SUBJECT: AMENDMENT NO. 96 TO FACILITY OPERATING LICENSE NO. DPR-43
(TAC NO. M83536)

Kewaunee Nuclear Power Plant

Amendment No. 96
License No. DPR-43

SAFETY EVALUATION BY THE OFFICE OF NUCLEAR REACTOR REGULATION
RELATING TO AMENDMENT NO. 96 TO FACILITY OPERATING LICENSE NO. DPR-43

Indicated Temperature (°F)
FIGURE TS 3.1-1

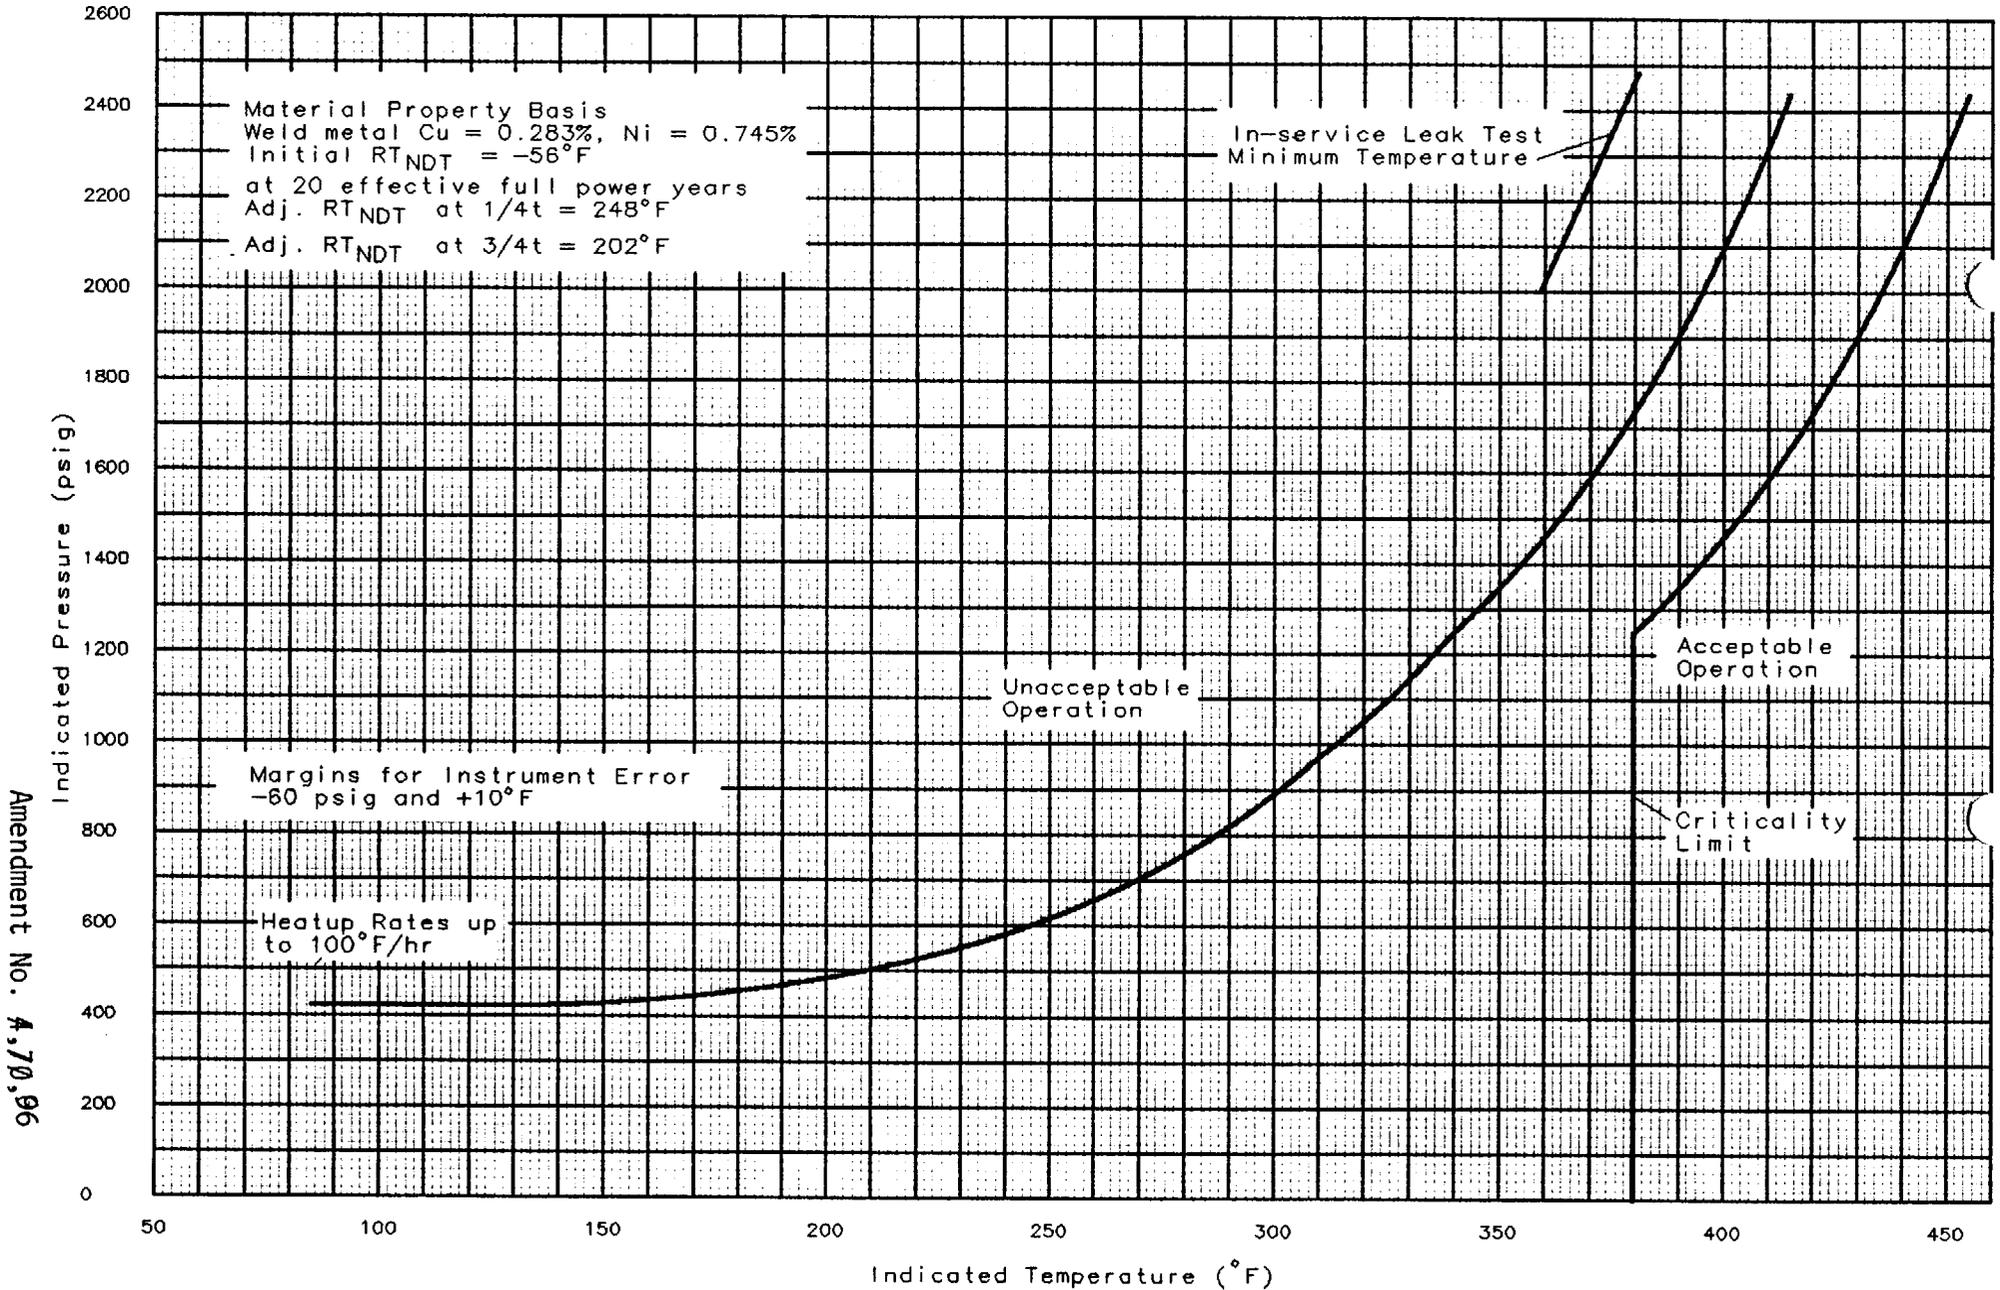
The amendment revises the Pressure/Temperature limits in Technical Specification (TS) Section 3.1.b, "Heatup and Cooldown Limit Curves for Normal Operation;" and, TS Figures 3.1-1 and 3.1-2 are replaced with new heatup and cooldown limit curves. Also, administrative changes are made to correct typographical errors and format inconsistencies.

1. The reactor coolant temperature and pressure and system heatup and cooldown rates (with the exception of the pressurizer) shall be limited in accordance with Figures TS 3.1-1 and TS 3.1-2 for the service period up to 20 equivalent full-power years.

Figures TS 3.1-1 and TS 3.1-2 are being revised to reflect the new heatup and cooldown curves discussed in the evaluation, and are acceptable. Section TS 3.1 and the bases for Section TS 3.1 are also being modified to reflect these revisions. Specifically, the service period for the heatup and cooldown curves on page TS 3.1-5 has been changed to 20 EFPY. In addition, the bases for TS 3.1.b.1, Fracture Toughness Properties, on pages TS 3.1-12 through TS 3.1-15 are being revised. The 1986 Edition of the ASME Boiler and Pressure Vessel Code is now being referenced, the referenced revision date of ASTM Standard E 262 is being changed to 1986, and Footnote 8 is being updated to reference the appropriate report. Furthermore, the third paragraph on page TS 3.1-13 is being modified to state that the allowable vessel pressure is obtained by taking the lesser of three values from the curves under consideration. On page TS 3.1-14, a reference to an outdated NRC Standard Review Plan is being deleted, Footnote 9 is being added, and Footnote 10 is being revised to reflect the current bases for fracture toughness properties. Finally, on page TS 3.1-15, a reference to WCAP-12020 is being added and the expiration date of the heatup and cooldown curves is being changed to 20 EFPYs. All of these changes updated the TS to reflect the new curves and, in
